1st Further Information

Proposed Temporary Heavy Goods Vehicle Park, Open Storage of Construction Materials and Machinery with Ancillary Facilities for a Period of 3 Years in “Village Type Development” Zone, Lot 2336 (Part) in D.D. 130, Nai Wai, Tuen Mun, New Territories

(S.16 Planning Application No. A/TM-LTYT/483)

Responses-to-Comments

DWG. TITLE
LANDSCAPE PLAN

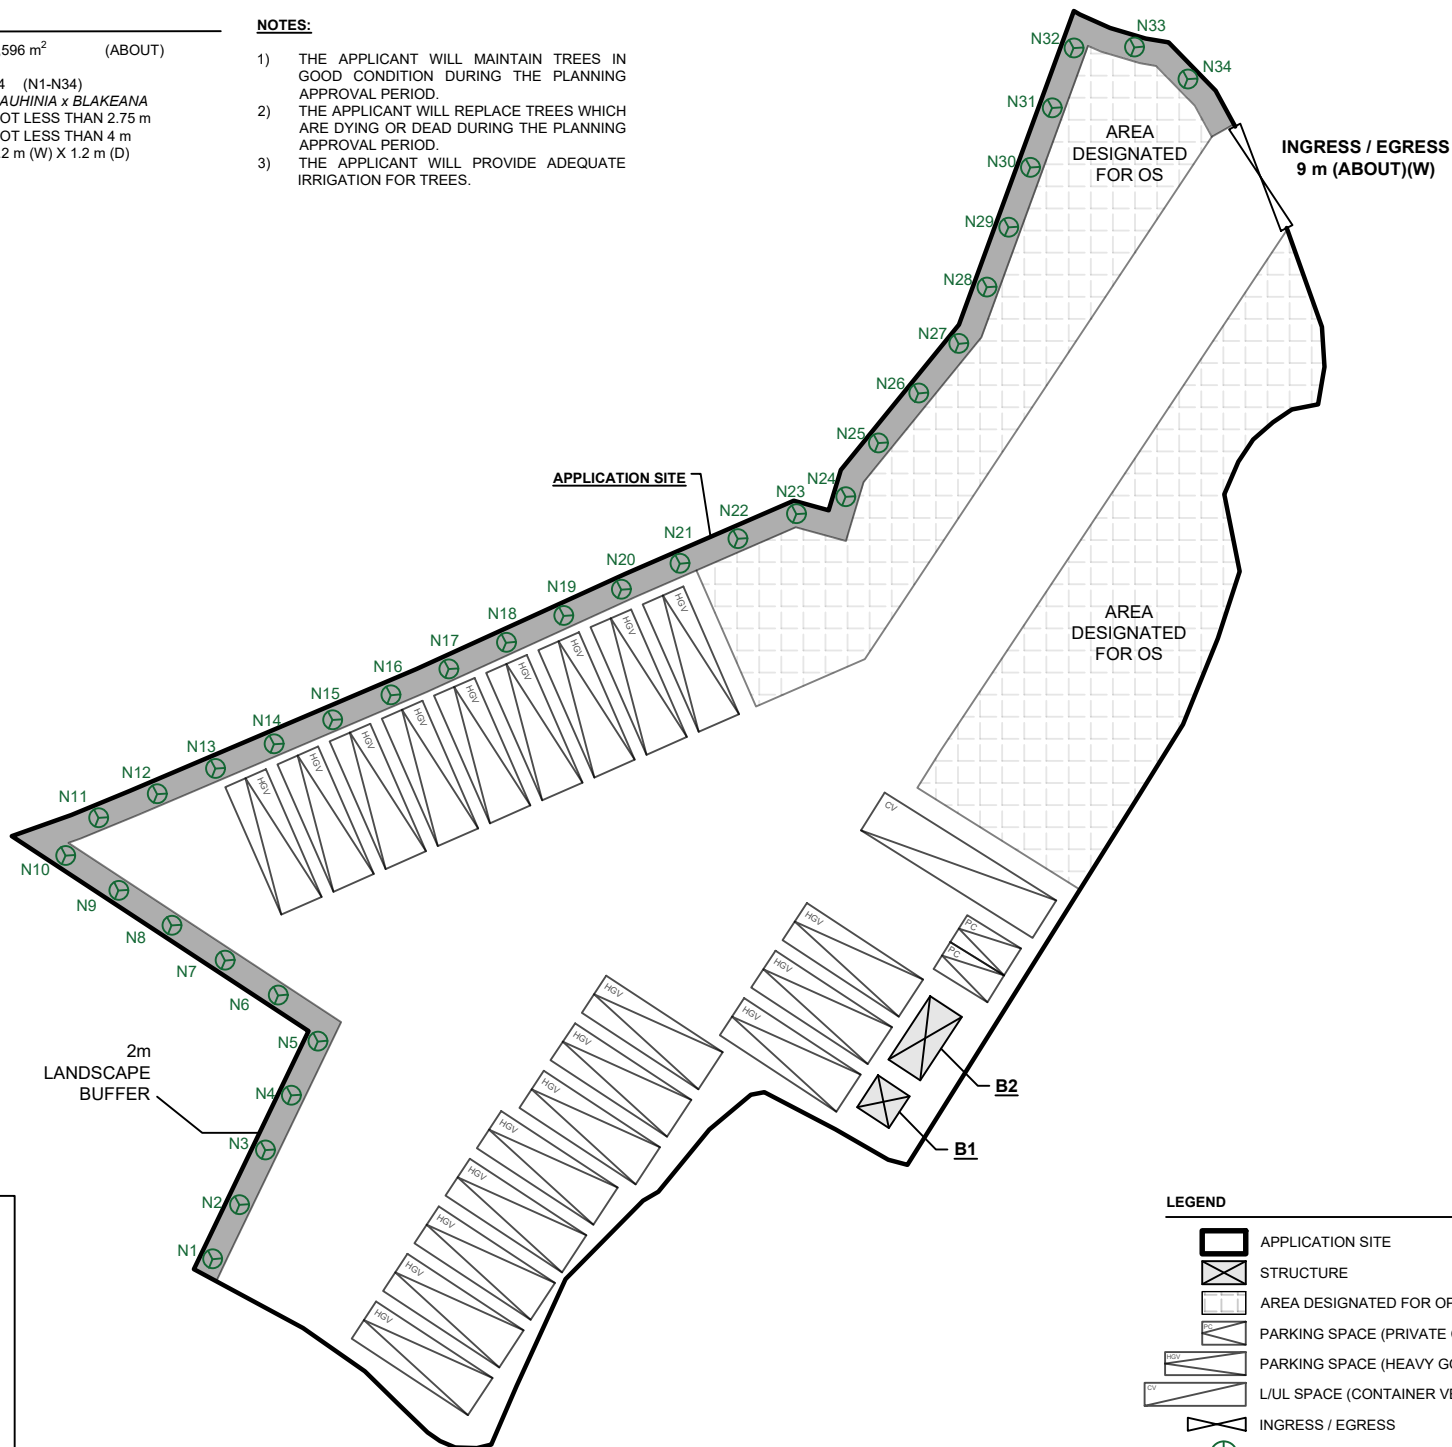
4. Comments of the Chief Town Planner/Urban Design & Landscape, Planning Department (CTP/UD&L, PlanD)		
(a)	Noting "a 2 m landscape buffer along the western and northern periphery of the Site is proposed" as shown in Para. 5.13 and the 'Layout Plan' (Dwg no. PLAN10), but no specified information of proposed planting and mitigation measures are included.	<p>The applicant proposes to plant 34 nos. of tree along the landscape buffer to reduce the potential adverse visual impact to the surrounding area.</p> <p>Please refer to the enclosed landscape plan at Annex 1.</p>

APPLICATION SITE AREA	: 4,596 m ²	(ABOUT)
NOS. OF TREE TO BE PLANTED	: 34	(N1-N34)
SPECIES OF NEW TREES	:	<i>BAUHINIA</i> x <i>BLAKEANA</i>
HEIGHT OF NEW TREES	: NOT LESS THAN 2.75 m	
SPACING OF NEW TREES	: NOT LESS THAN 4 m	
DIMENSION OF TREE TRENCH	: 1.2 m (W) X 1.2 m (D)
